SUBJECT: 18th and Northwestern Parkway Storage Basin
Minor Project Modification
IOAP Project No. L_SO_MF_190_S_09B_B_A_8

Subject: Chenoweth Hills WQTC Elimination, Chenoweth Run and Chippewa PS Improvements
Minor Project Modification
IOAP Project No. S_JT_JT_NB01A_M_03_C
DOJ Case No. 90-5-1-1-08254

Subject: Goose Creek PS Phase 1 – Devondale Wet Weather Storage
Minor Project Modification
IOAP Project No. S_MI_MF_NB04_M_03_B
DOJ Case No. 90-5-1-1-08254

Subject: St. Rene Road Pump Station In-Line Storage
Minor Project Modification
IOAP Project No. S_FF_CH_NB01_S_09A_C_A
DOJ Case No. 90-5-1-1-08254

CSO190 Green Infrastructure Solution

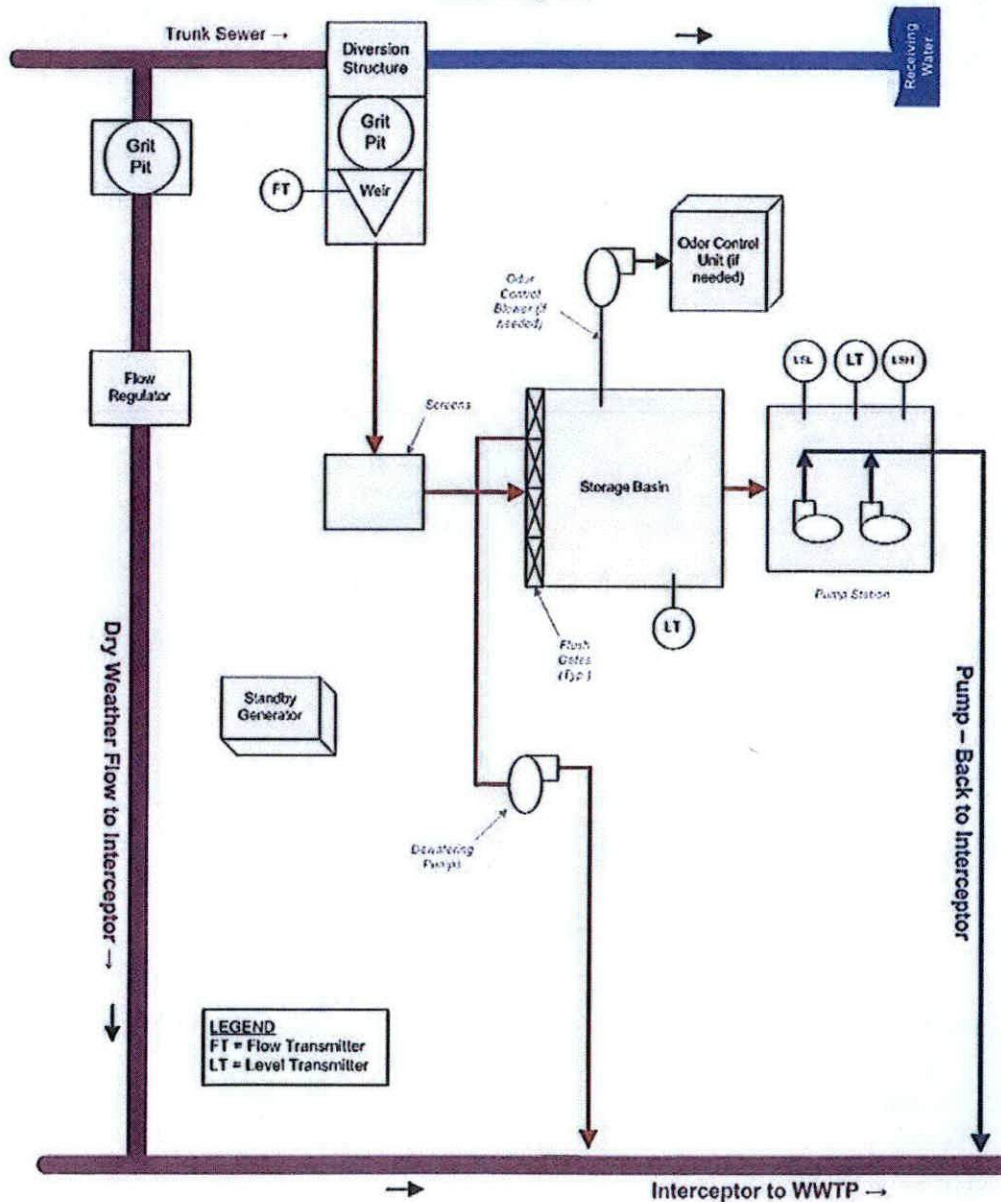
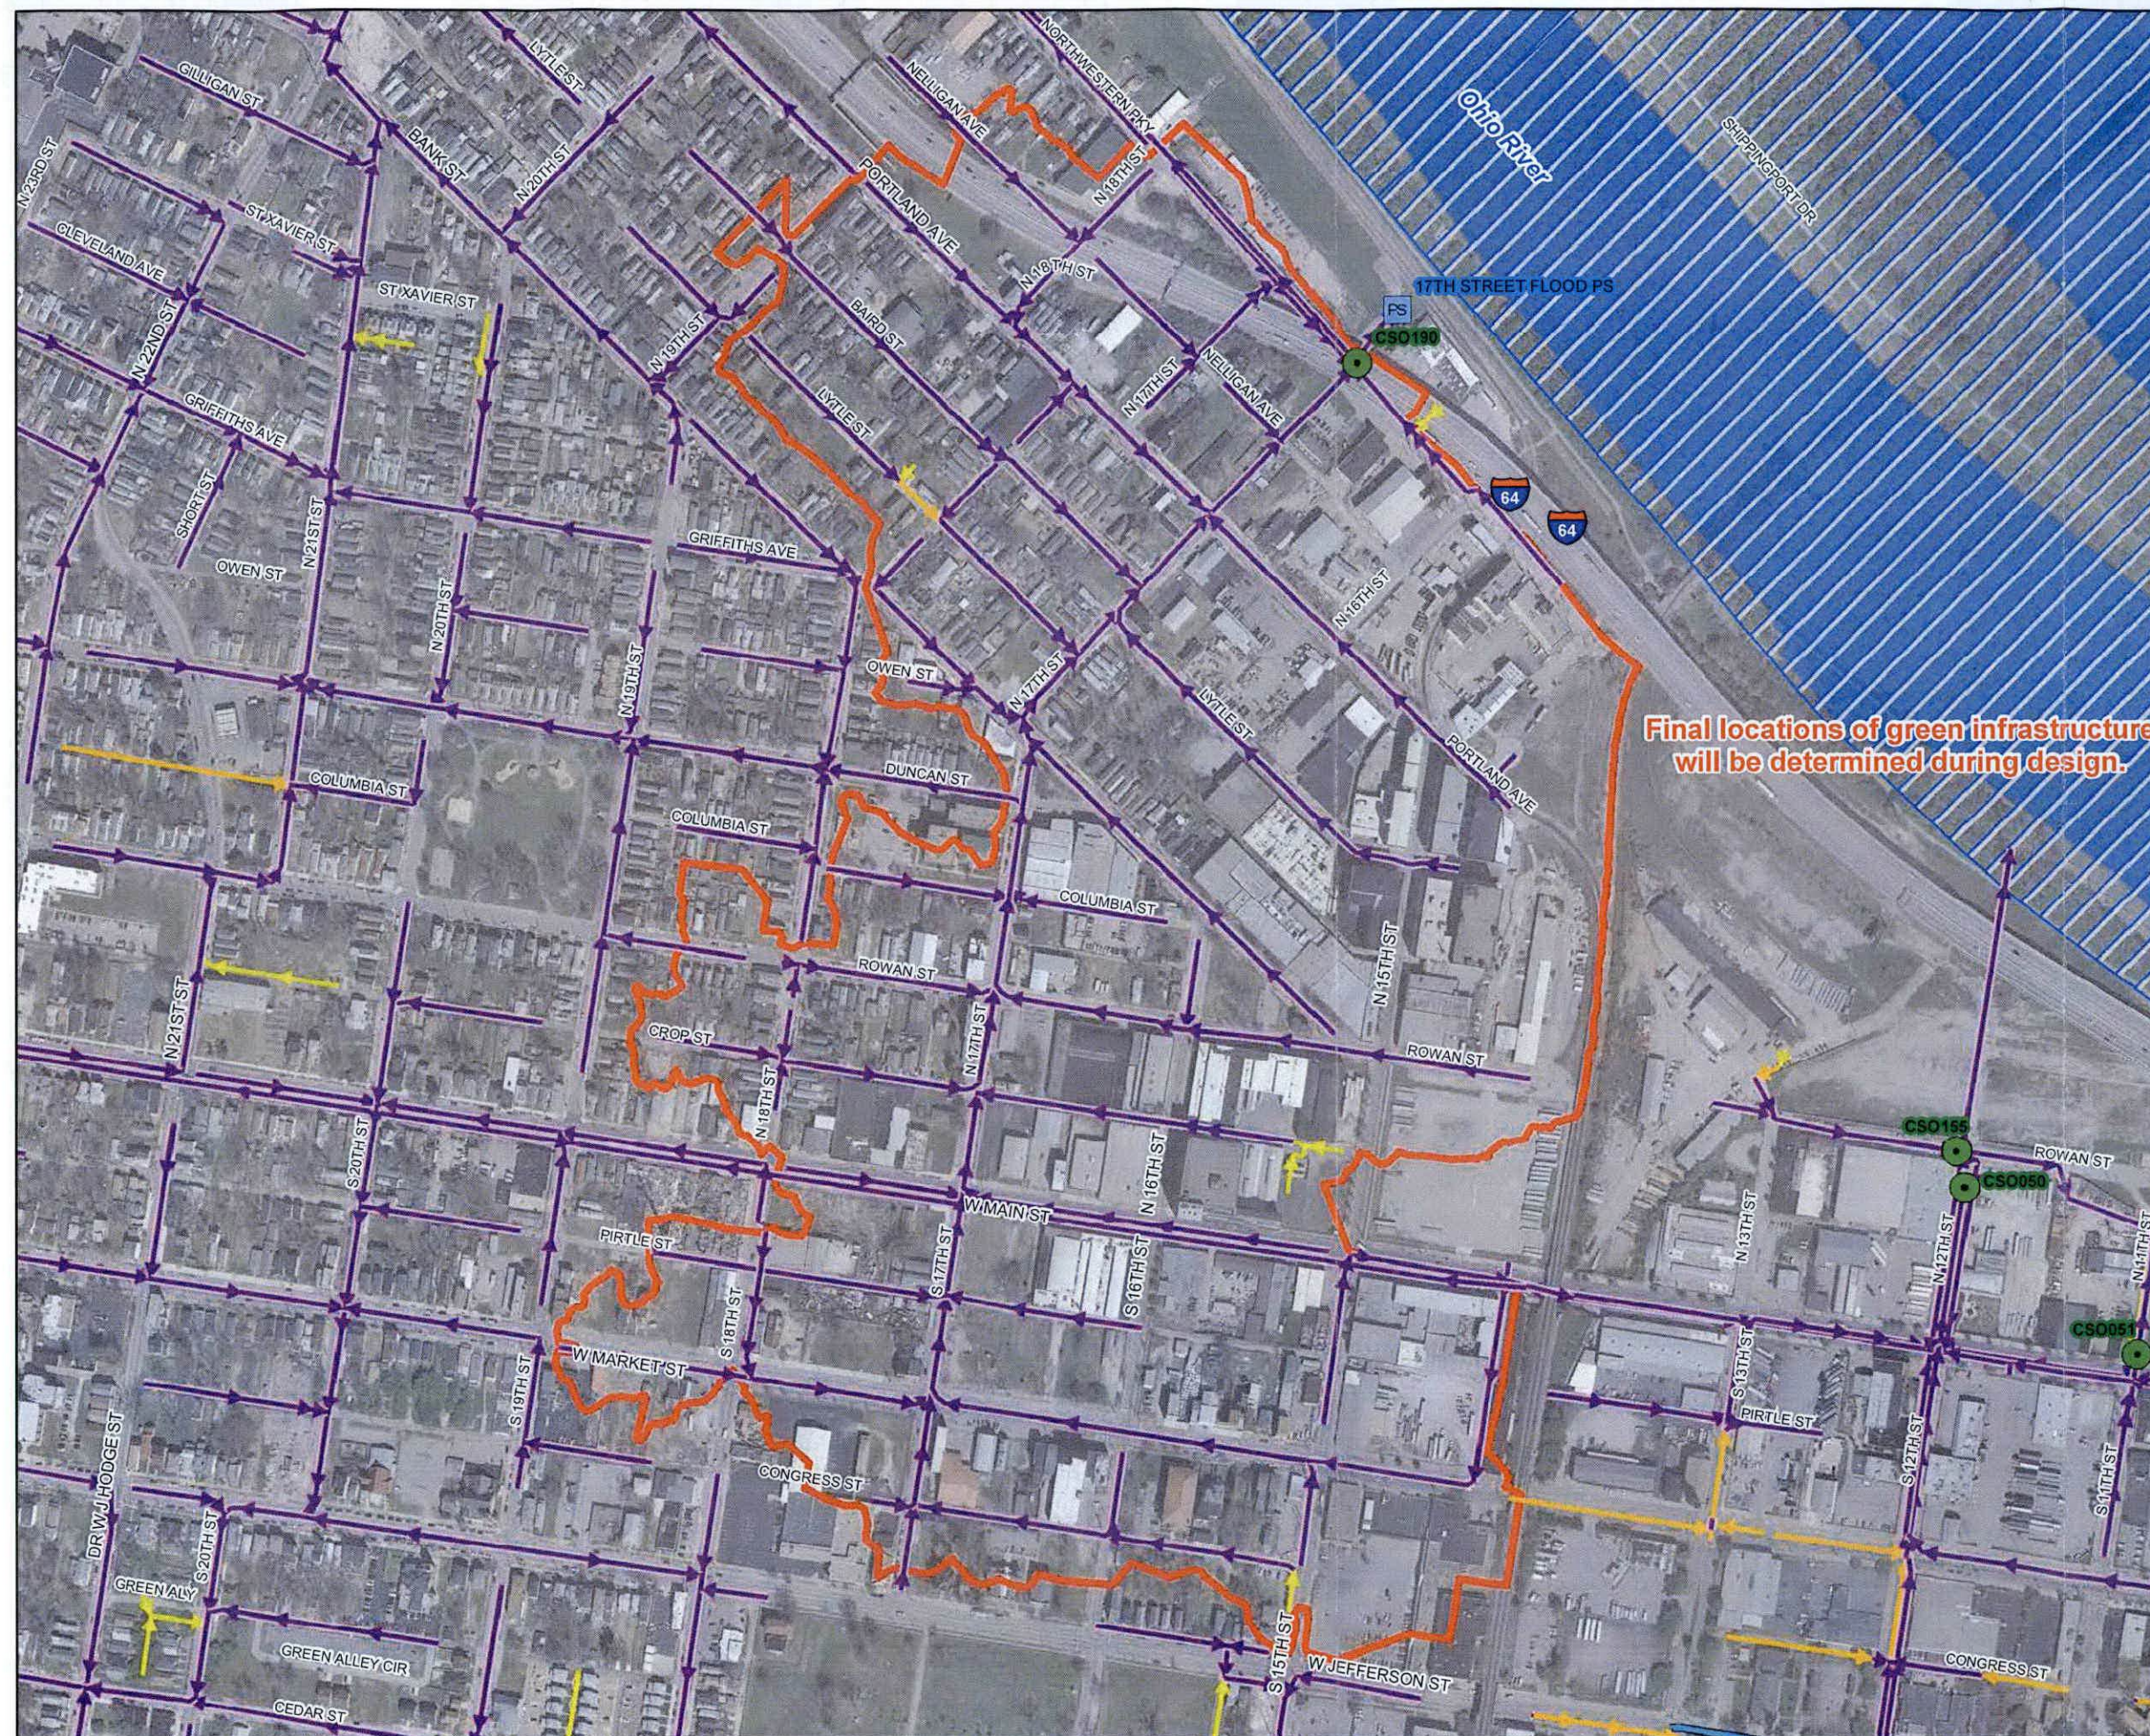
With the success of the green infrastructure solution for CSO 130, MSD has carefully considered the life cycle savings and the other community benefits of a green infrastructure approach, and has decided to implement green infrastructure to control CSO 190. Hydraulic modeling has confirmed that the proposed green infrastructure solutions could reduce the 54 current overflows per typical year to eight. As the design process continues, MSD will have the opportunity to optimize the specific approach and implement a variety of green infrastructure practices including open tree boxes, rain gardens, bioswales, downspout disconnections, and underground infiltration to reduce the volume of flow and pollutants to CSO190.

A revised project fact sheet and map is included as Attachment B to illustrate how MSD intends to achieve the level of control through green infrastructure practices, potential modifications to the diversion structure, and/or distributed storage throughout the CSO190 sewershed. The project will be renamed, 'CSO 190 Green Infrastructure Solution'. For your reference, copies of the project fact sheets and maps from the 2009 IOAP and 2012 IOAP Modification are enclosed in Attachment c.

Project Description: This project is a suite of green infrastructure practices sized and located to reduce the number of overflows from CSO190 to 8 per year in a typical year. The practices include 6 areas of targeted tree plantings, 5 rain gardens, 9 vegetated infiltration trenches (including 1 with additional tree plantings) and 130 underground infiltration galleries. Practice locations are illustrated on the project map.

Integrated Overflow Abatement Plan
Vol. 3 - Sanitary Sewer Discharge Plan
Jefferson County Sewershed
Chenoweth Hills WQTC, Chenoweth Run and Chippewa PS Eliminations

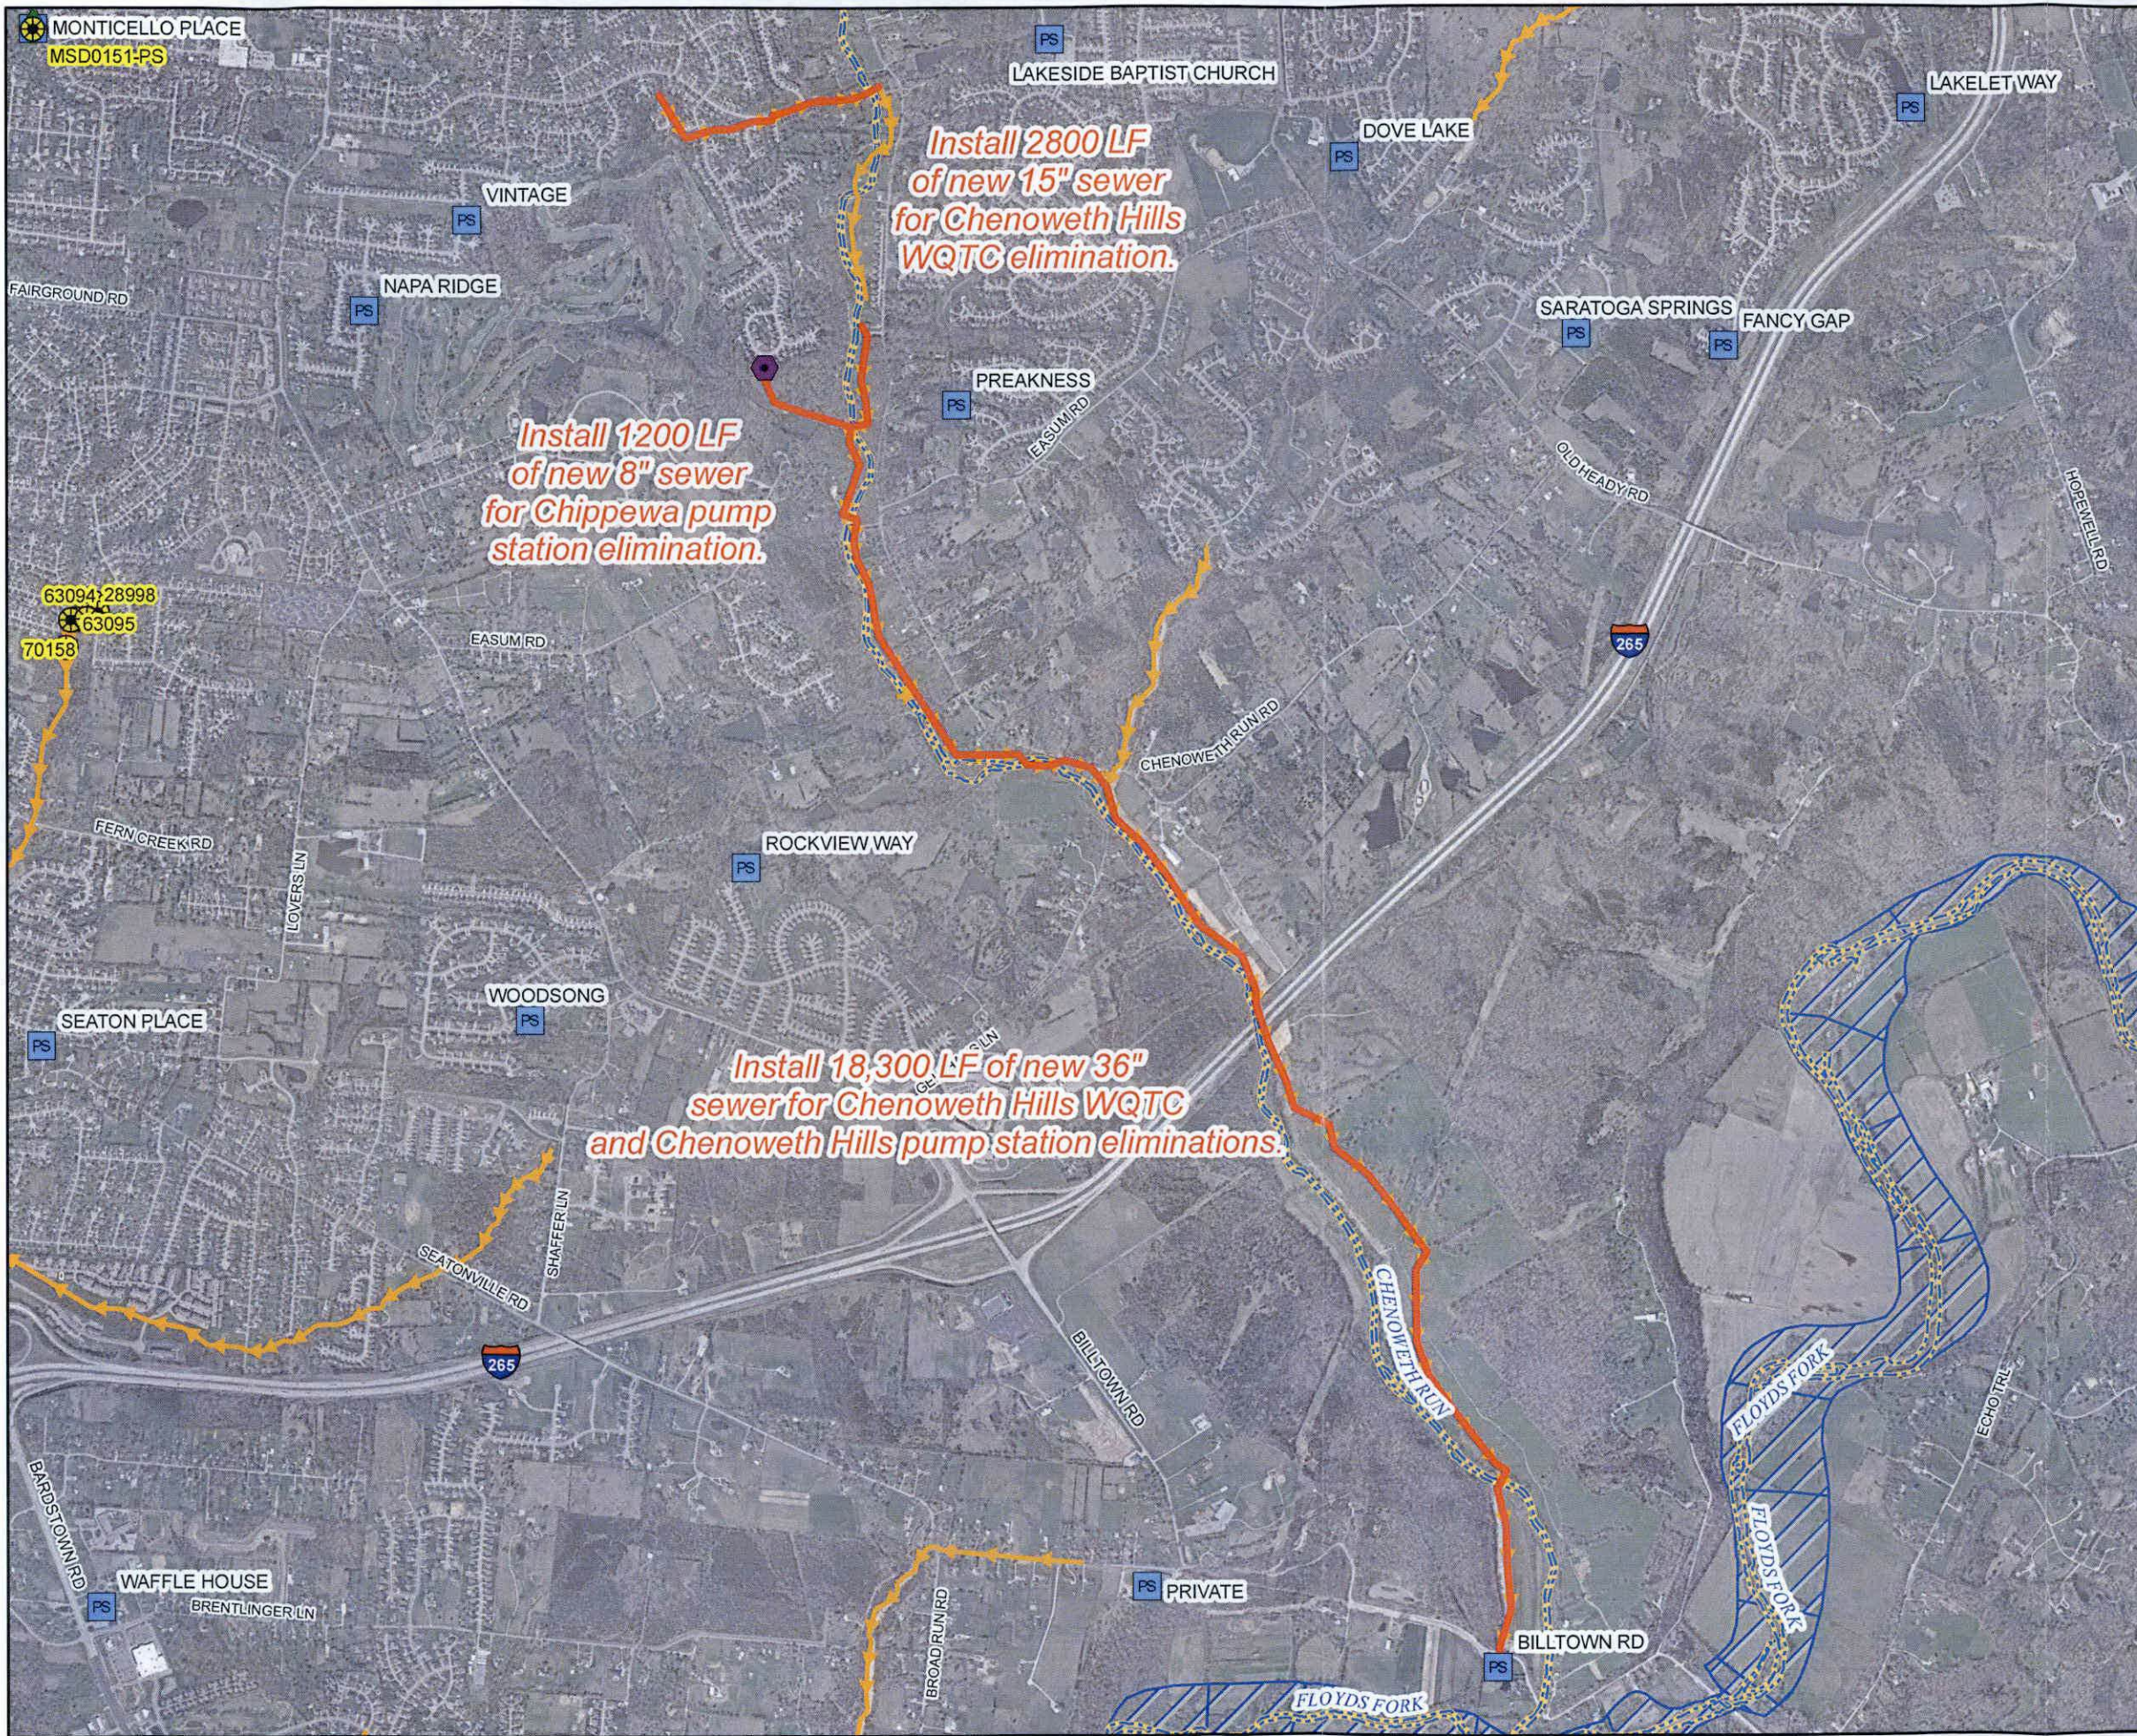
The project modification proposed constructs 2,800 LF of 15-inch and 1,200 LF of 8-inch diameter gravity sewer to allow elimination of the Chenoweth Hills WQTC, and also eliminate (not upsizing) the Chenoweth Run and the Chippewa Pump Stations. This provides the same level of protection as the original project, but at a greatly improved level of reliability since two existing pump stations are eliminated. No change in project schedule is proposed.

For your reference, a copy of the current project fact sheet and map from the 2012 IOAP Modification are in Attachment A. A new project fact sheet and map reflecting the location of the new pipeline routes have been provided in Attachment B.

Project Description This alternative includes eliminating Chenoweth Hills WQTC, Chenoweth Hills PS, and Chippewa PS. Install 18,300 LF of new 36" sewer, 2800 LF of new 15" sewer for Chenoweth Hills WQTC diversion, and 1200 LF of new 8" gravity sewer to eliminate Chippewa pump station.
